# PROPOSED DEVELOPMENT AT McCABE STREET MOSMAN PARK

# LANDBANK

# Report and Recommendations of the Environmental Protection Authority

Environmental Protection Authority Perth, Western Australia Bulletin 324 April 1988

Fig. 2a Boundaries 0 Th development site (Source 0 H ₽ig. .:PER)

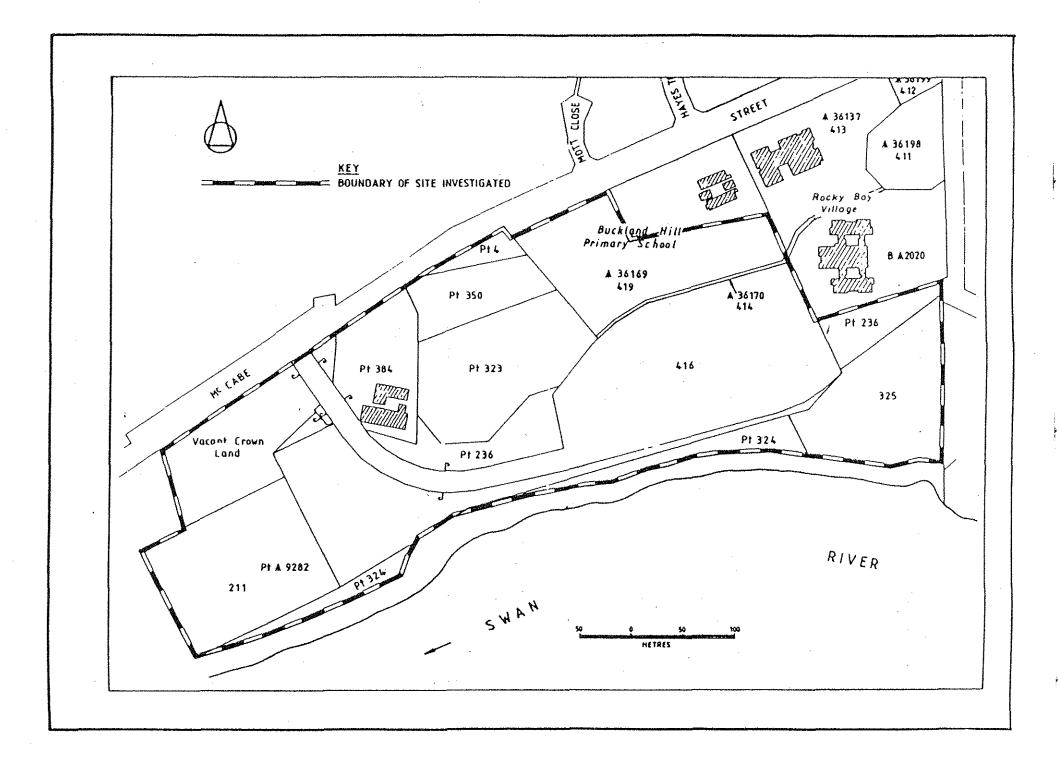
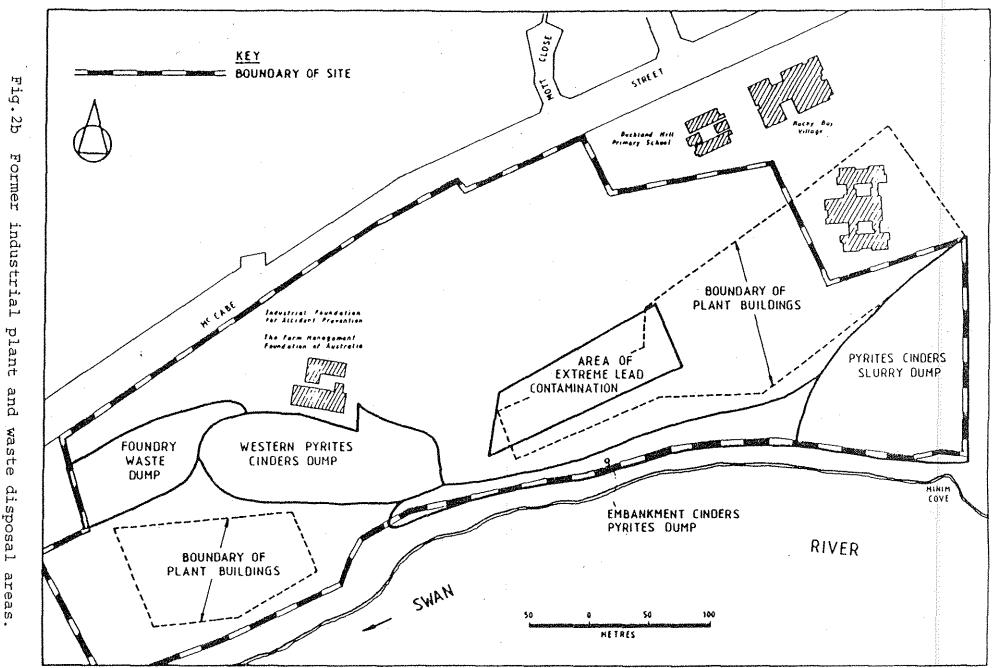
The Analabs study established various degrees of surface soil contamination within lot 416 (Fig.2a) while the Technical Assessment Group concluded that:
